Old Georgetown Estates, Preliminary Plan No. 120190230

Request to subdivide one parcel to create four lots, for four new single-family detached dwelling units, and two parcels for stormwater management and parkland dedication.

PRELIMINARY PLAN - M-NCP&PC No. 120190230

SHEET TITLE:
Preliminary Plan

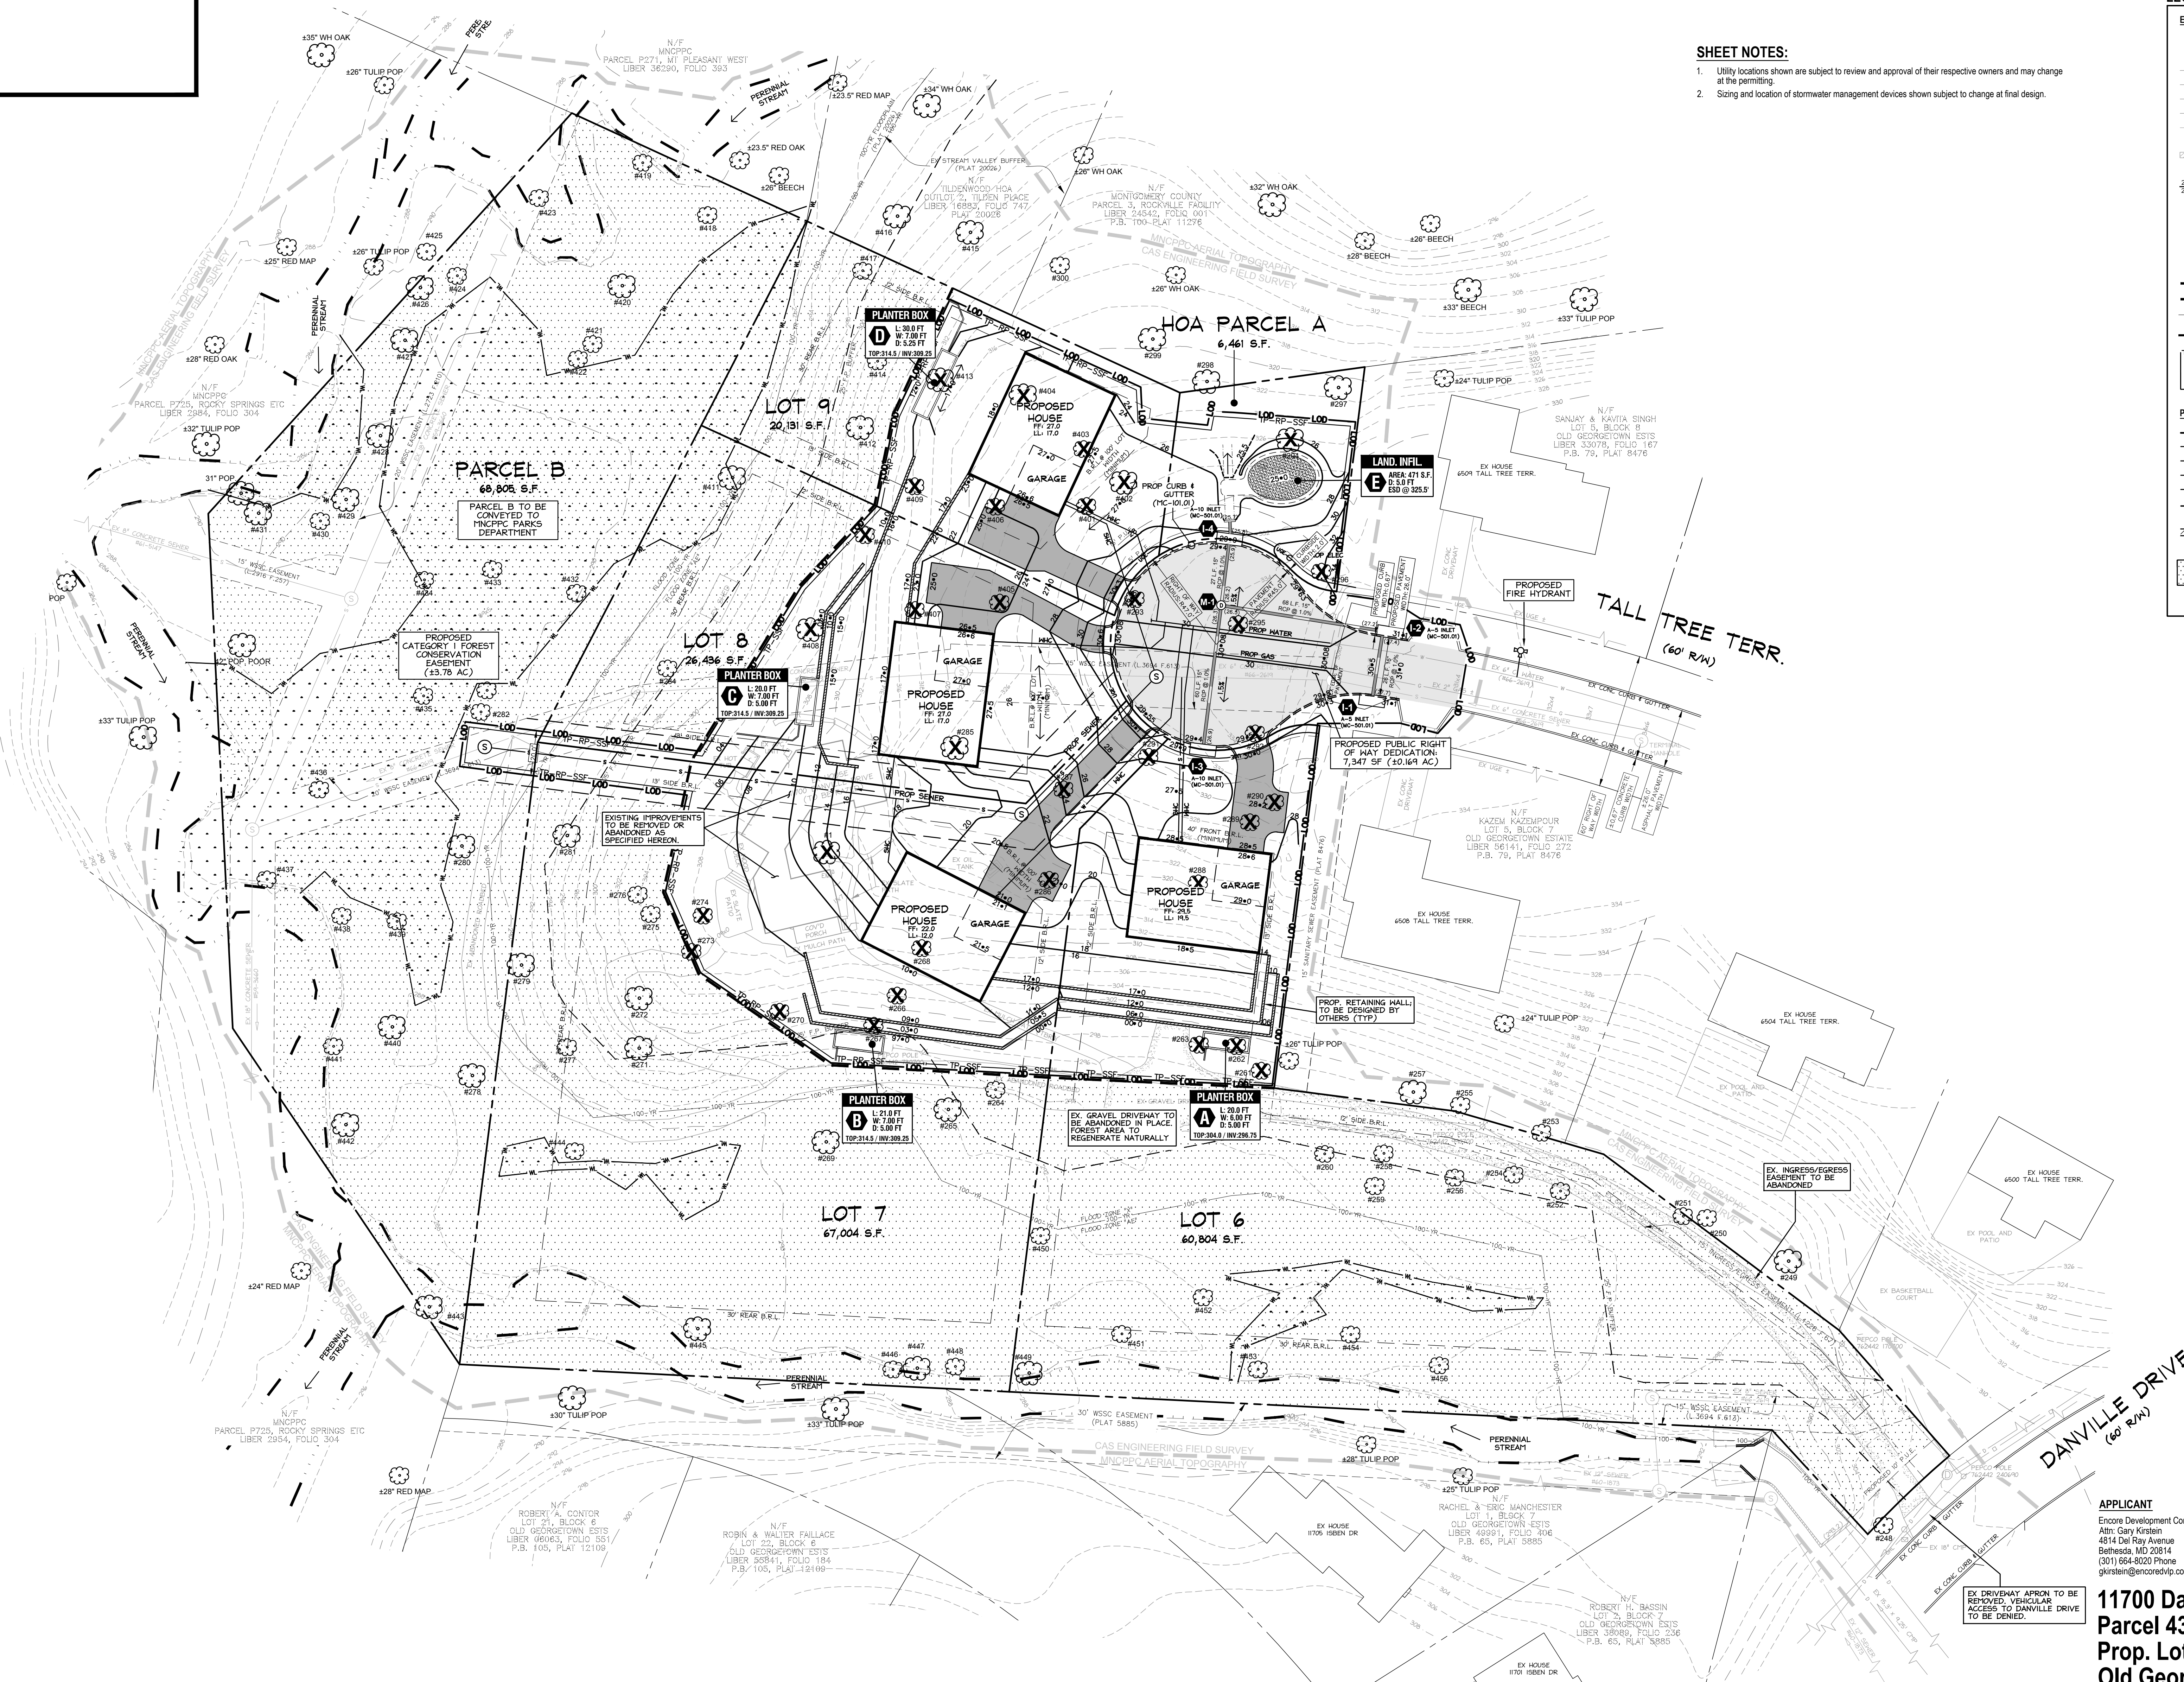
MCDOT Response: The applicant's request is to reduce the required right-of-way for a standard cul-de-sac from 120-feet to 94-feet. This request is not a design exception, instead MCDOT makes a recommendation to the Planning Board based on County Code 50.4.3.E.2.a.i., which allows for "narrower right-of-way if it meets minimum fire access requirements and the Board finds that a narrower right-of-way is ... environmentally preferable." The setback for buildings in this zone is 40 feet. If the right-of-way were kept at the standard, then the buildings would be setback further from the street and more in the steep slopes. This reduction proposes the development to remain closer to the proposed improvements and allows for additional protections of existing natural resources via more extensive long-term protective easements. **MCDOT recommends the Planning Board approve the reduced right-of-way from 120 to 94 feet.** This section will include a 5-foot public improvement easement per preliminary plans.

- B. Remove the island that is required per the standard MC-222.01 in order to remain in compliance with the established fire department access requirements.

MCDOT Response: MCDOT **recommends approval** to exclude the cul-de-sac island from the proposed cul-de-sac based on the fire department approval. The applicant should provide a copy of the letter from the fire department stating the above.

MCDOT Response: MCDOT **recommends approval** of a reduced cross slope which meets AASHTO's accepted minimum values for cross slope per section 3.3.3.

MCDOT Response: We are not aware of any waiver process for pavement spread for the proposed sump inlet I-4. However, since Tall Tree Terrace is classified as a secondary residential street, the Montgomery County's Drainage Design Criteria section 4.2.1 states "tertiary and secondary roadway: water shall not cross the centerline and may not exceed 13 feet". Therefore, we believe, the applicant is meeting the requirements for pavement spread for the proposed sump inlet I-4 on Tall Tree Terrace.

1. Waiver from the Montgomery County Planning Board for overlength cul-de-sac(s) may be needed per County Code 50.4.3.E.2.h.iv.
2. **Storm Drain Analysis:** The revised storm drain study dated October 1, 2019 was accepted by MCDOT. The applicant is not responsible for any improvements to the existing publicly maintained downstream storm drain outfall.

3. Provide a 15-foot wide Public Utility Easement (PUE) along all existing street frontages. There is a 5-foot Public Improvement Easements (PIE) proposed. Therefore, the PUE will need to be increased to 15-feet.
